RADIO RECEIVER R-390A/URR

ELECTRONICS FIELD CHANGE BULLETIN
NAVAL SHIP ENGINEERING CENTER, NAVY DEPARTMENT
WASHINGTON, D. C.

6-R390A/URR

INTERNAL HEAT REDUCTION
FSN N5820-937-0141

Figure 1. Correction to figure 89-1.

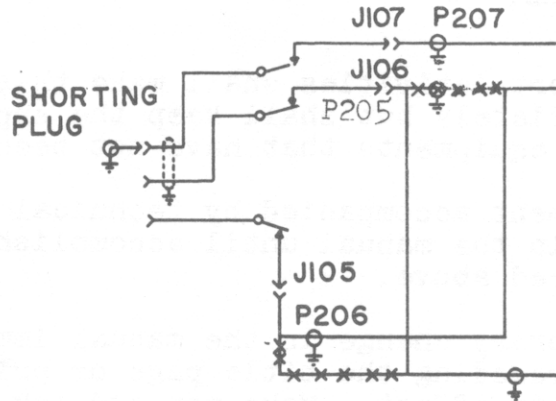
f. Page 178, figure 89-1:

(1) Correct antenna input connections at upper left side of page as shown in figure 1 of this article.

(2) Delete "125 ohm Balanced" in J104 block at left of antenna input.

(3) Below antenna input wiring, write "Antenna input modified on shipboard installations by Field Change 5. Shipboard installations use J103."

FIGURE 89 (2) --- NAVSHIPS 93053

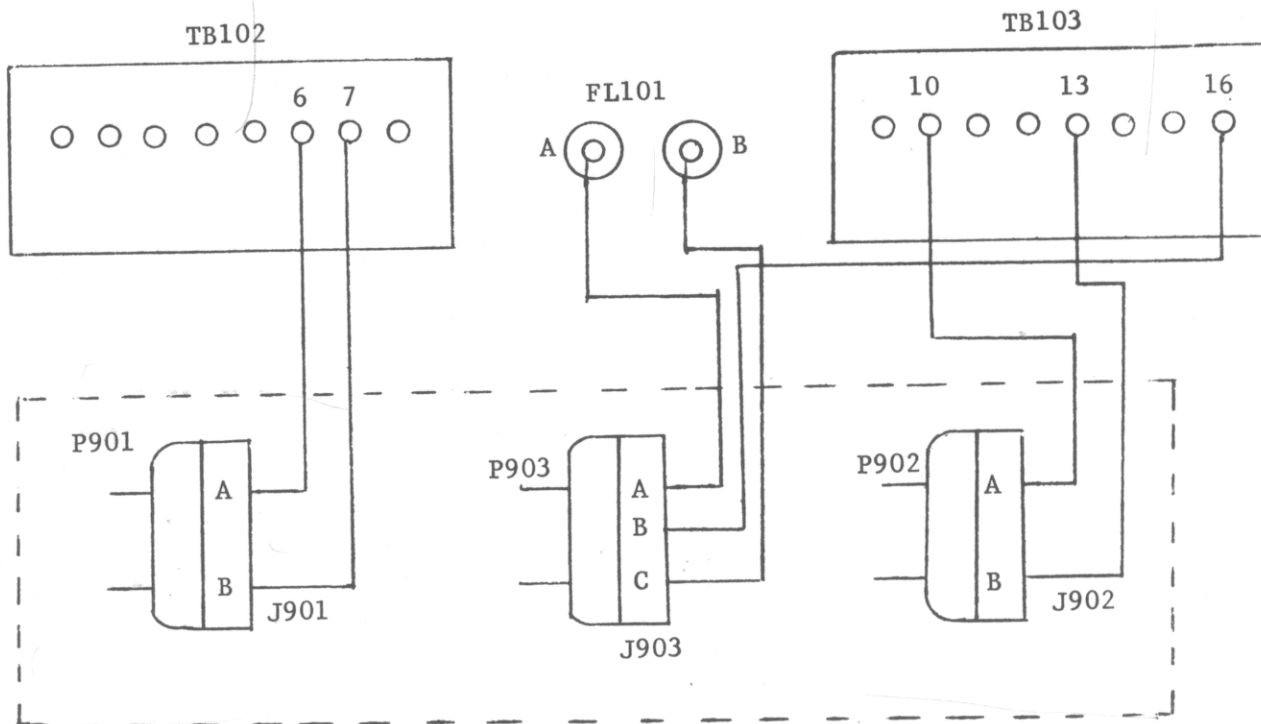
Figure 89, sheet 2: Delete wire between P120-11 and shielded ground 1/4 inch above P120-11. Change shielded ground connection into a test jack and at right, label "J904-Diode Load Test Jack."

Figure 5. Running spares.

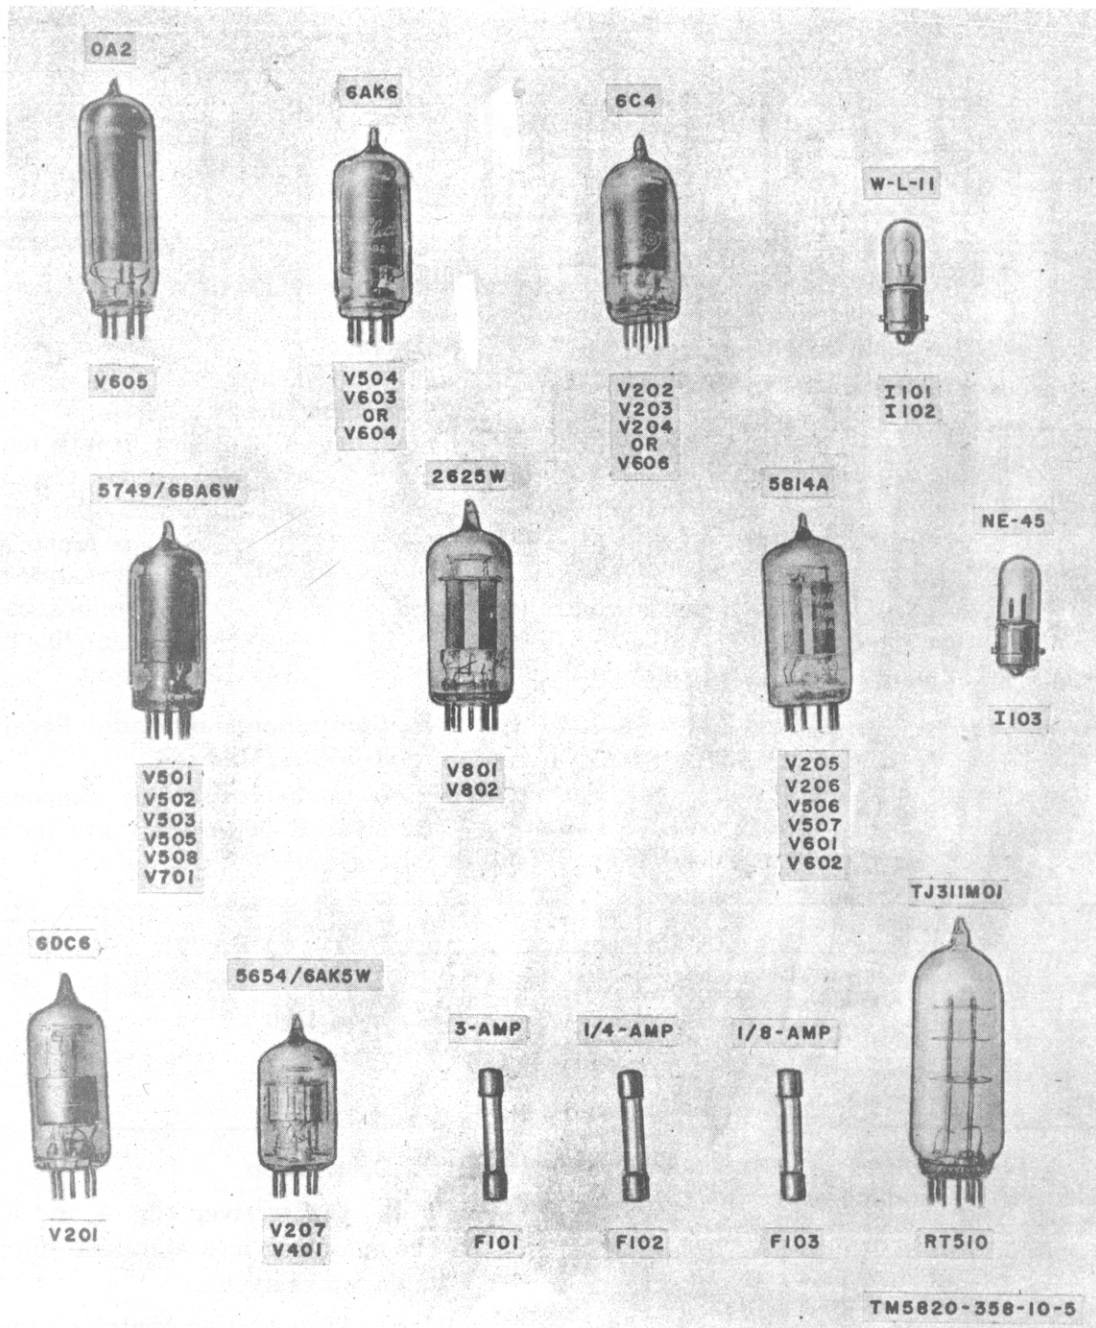
9	Figure 5	Delete those parts of the illustration associated with:
---	----------	---

9	Figure 5	Delete those parts of the illustration associated with: <ul style="list-style-type: none"> (a) "600 ohm speaker" (b) "To 115/230 volts AC 48 to 62 CPS" (c) "Balanced 600 ohm audio line to auxiliary equipment"
---	----------	---

Add: "The cables are now terminated with "AN" plugs which are connected to the receptacles shown in Figure 1 of T-1(A) NAVSHIPS 93053."

The cables are now terminated with "AN" plugs which are connected to the receptacles shown in Figure 1 of this temporary correction.

Figure 7. Rear panel.

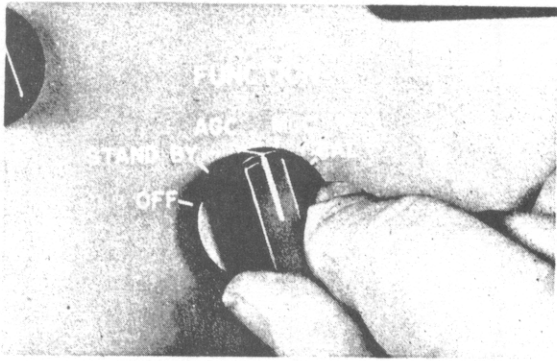
11	Figure 7	Add: "This panel is now modified. See Figure 1 of T-1(A) to NAVSHIPS 93053."
----	----------	--

11	Figure 7	Add: "This panel is now modified. See Figure 1 of this correction."
----	----------	---
